**QUALITY ASSURANCE -- NON-CONFORMANCE REPORT**

**Location:** Changxing Island, Shanghai, P.R. China **Report No:** NCR-000547  
**Prime Contractor:** American Bridge/Fluor Enterprises, a JV **Date:** 15-Dec-2009  
**Submitting Contractor:** Zhenhua Port Machinery Company, Ltd (ZPMC), Changxing Island **NCR #:** ZPMC-0520

**Reference Description:** Missed UT Indication by QC, Segment 7CW

**Job Name:** SAS Superstructure  
**Document No:** 05.03.06-000508

| 项目名称<br>Project Name | 美国海湾大桥<br>SFOBB | 部件图号<br>Drawing No | SEG037A                                  | 报告编号<br>Report No.           | B-WR12122     |

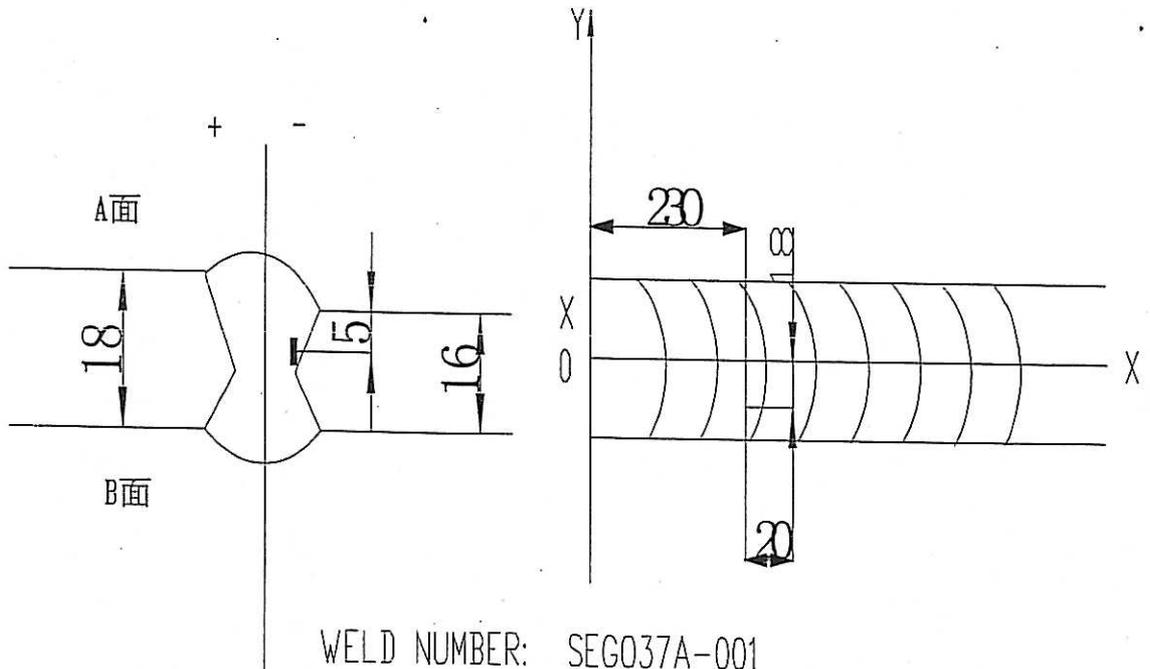
Rejected indication found by ultrasonic inspection is less than the maximum allowance aggregate length.

(UT探伤发现的缺陷总长度小于最大允许长度。) SEG037A-001

1. Did not clear the weld pass completely in time.

1. Gouge or grind from nearer side from metal edge ( $D \leq 0.65T$ , " $D$ " is depth of defects, " $T$ " is thickness of metal) to remove all defects;

2. Follow repair WPS for joint preparation, preheat, and weld deposit;

3. Verify with VT no defects remain in the weld joint prior to welding;

4. Grind the repaired area flush with base metal or the adjacent weld;

5. Perform UT inspection to the weld along with 50mm on each end of the repair area;

WELD NUMBER: SEG041C-013

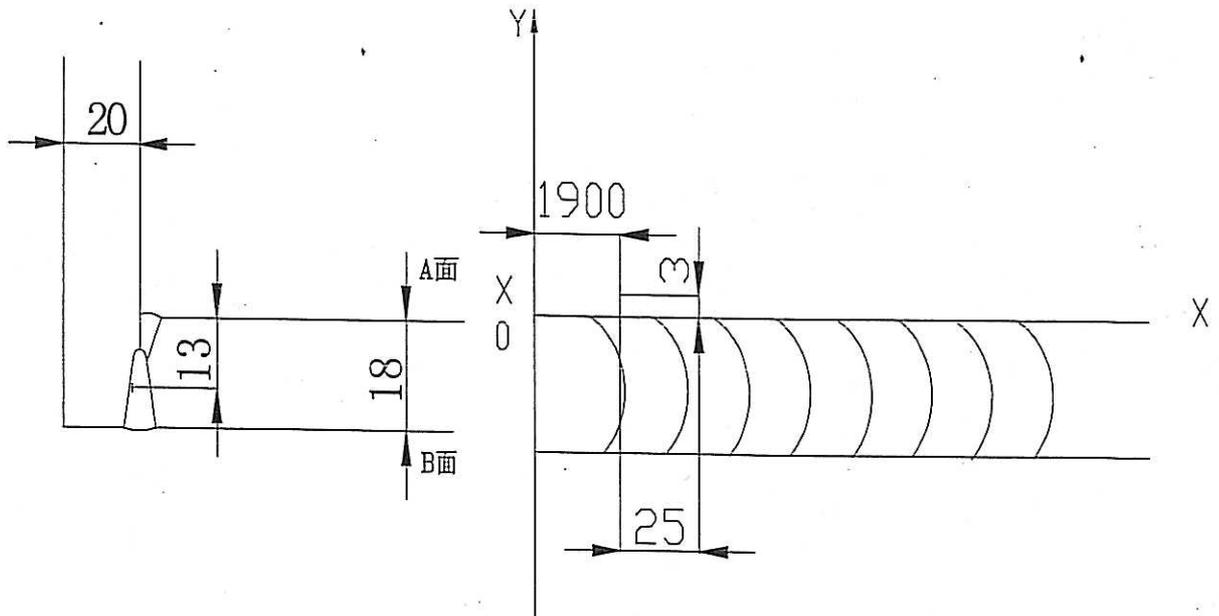
Rejected indication found by ultrasonic inspection is less than the maximum allowance aggregate length.

(UT探伤发现的缺陷总长度小于最大允许长度。) SEG041C-013

1. Did not clear the weld pass completely in time.

1. Gouge or grind from nearer side from metal edge ( $D \leq 0.65T$ , "D" is depth of defects, "T" is thickness of metal) to remove all defects;

2. Follow repair WPS for joint preparation, preheat, and weld deposit;

3. Verify with VT no defects remain in the weld joint prior to welding;

4. Grind the repaired area flush with base metal or the adjacent weld;

5. Perform UT inspection to the weld along with 50mm on each end of the repair area;

-The weld is identified as CA051-010 at panel point (PP64.5 in Segment 8BE).

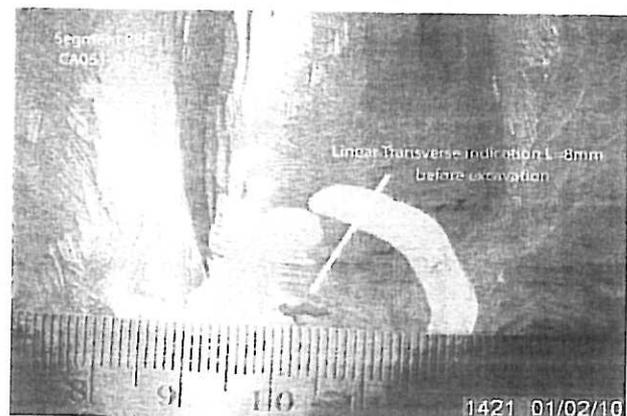
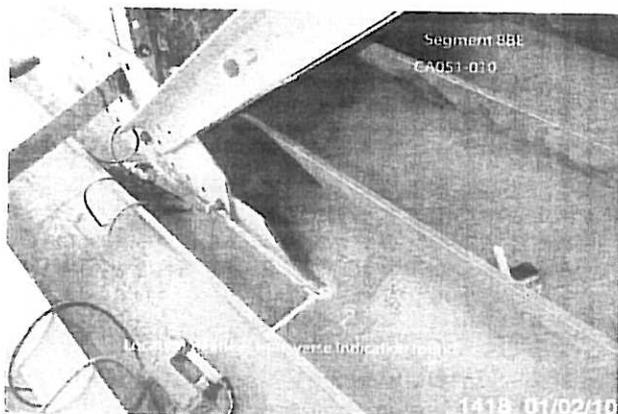
During the Quality Assurance Magnetic Particle Testing (MT) review of welds located on OBG Corner Assembly, this Quality Assurance Inspector (QA) discovered the following issue:

-One (1) Transverse linear indication that measured approximately 8mm in length.

-The weld is a fillet weld joining the Vertical Longitudinal Truss (X74H) to the Side Plate (SP458A)

Repair said indication and perform NDT required to verify weld quality.
